## ADDENDUM NO. 2

DATE: February 10, 2025

PROJECT: ORCHARD VALLEY GOLF COURSE BRIDGE REPLACEMENTS

FROM: Engineering Enterprises, Inc.  
52 Wheeler Road  
Sugar Grove, Illinois 60554

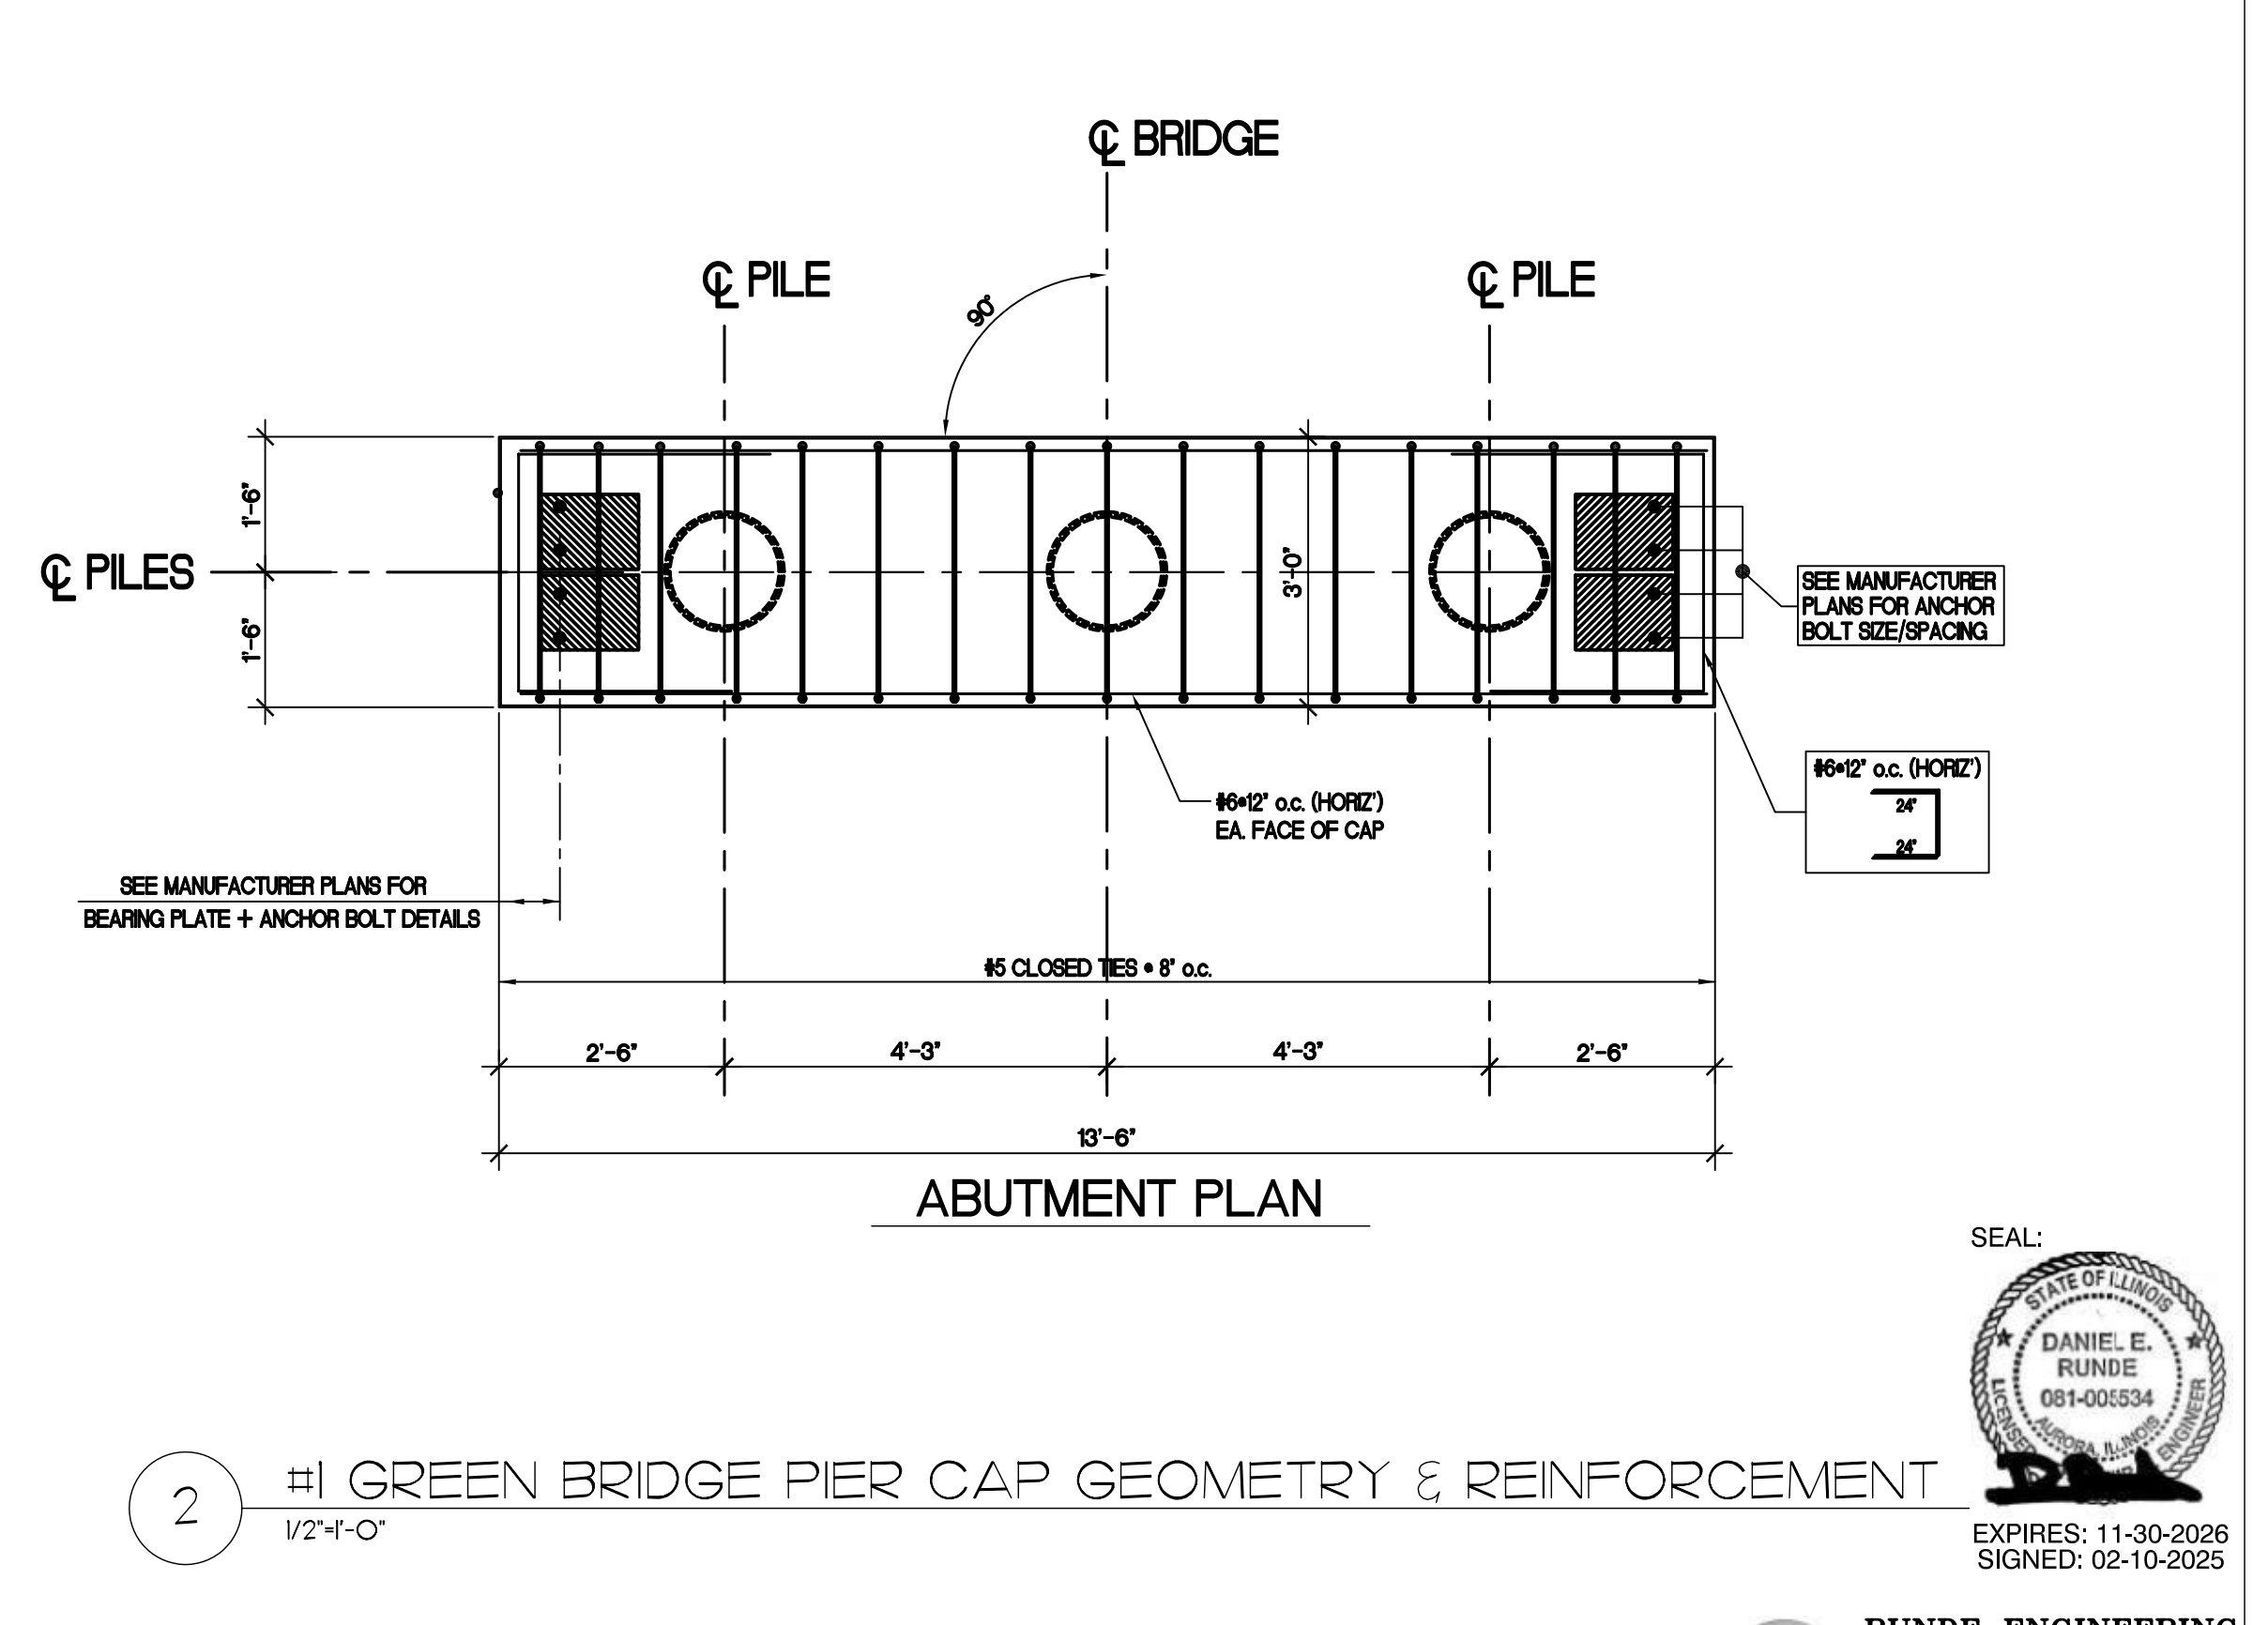
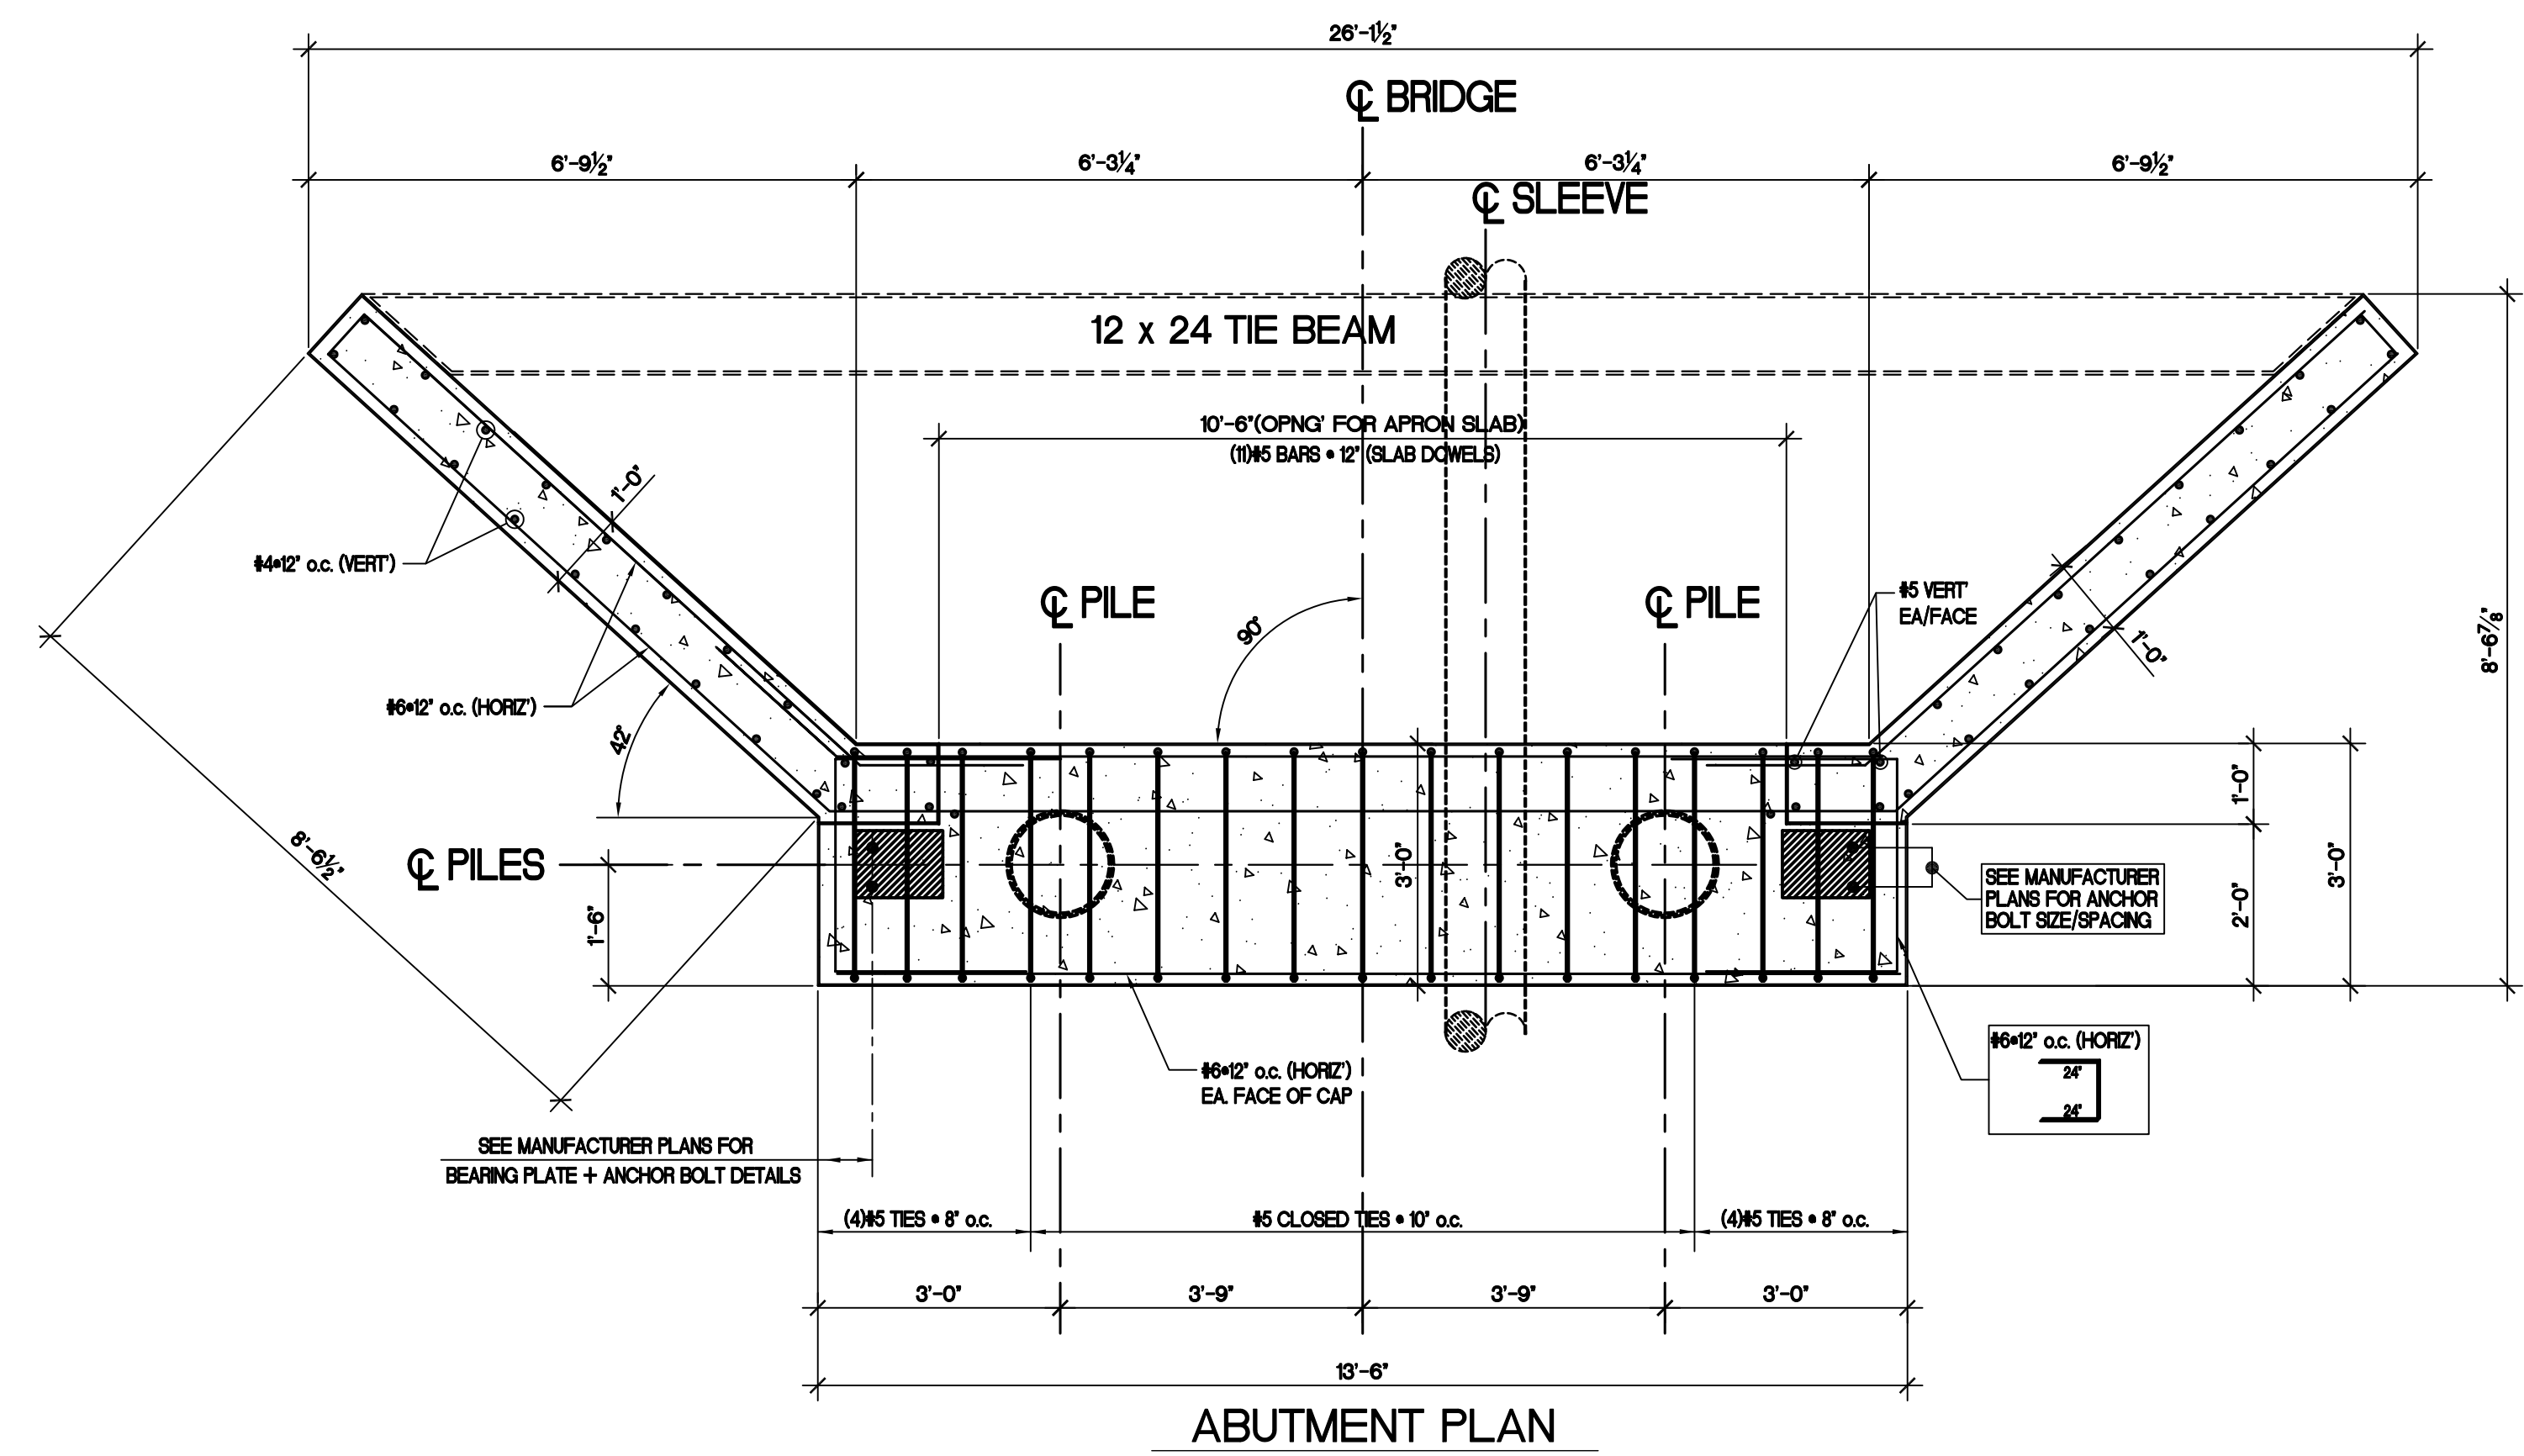
7. **Question 7:** *Can Item 21 TEST PILE METAL SHELL and Item 22 Driving Piles be performed to IDOT Standard Specifications, Design Manual, procedures and methods as opposed to what is detailed on Page S2 of 13 in the Hollow Shell Piling Notes. Methods detailed on Page S2 of 13 in the Hollow Shell Piling Notes are not local industry standard practice and lacks clarity, the Contractors that will provide pricing for this project typically drive piling according to IDOT Standards, Design Manual, and procedures with the Owners Rep/Engineer typically providing determination of bearing, pile record keeping and furnished lengths. The cost of the Independent Testing Laboratory, directed by a Professional Engineer (Hollow Shell Piling Note 8) and the Compression Load Test according to ASTM D 1143 (Hollow Shell Piling Note 9) will add several hundred thousand dollars to the contract time that can be avoided by following IDOT Standards, Design Manual, and methods.*

8. **Question 8:** What concrete mix shall be used to fill the shell piles. IDOT typically use a drilled shaft mix.

**Response to Question 7:** Following IDOT Standards is acceptable. In lieu of using a test pile, driving piles to refusal is an acceptable alternate.

**Response to Question 8:** IDOT class DS mix shall be used. (4,000 psi) Please refer to sheet S2 for mix design information.
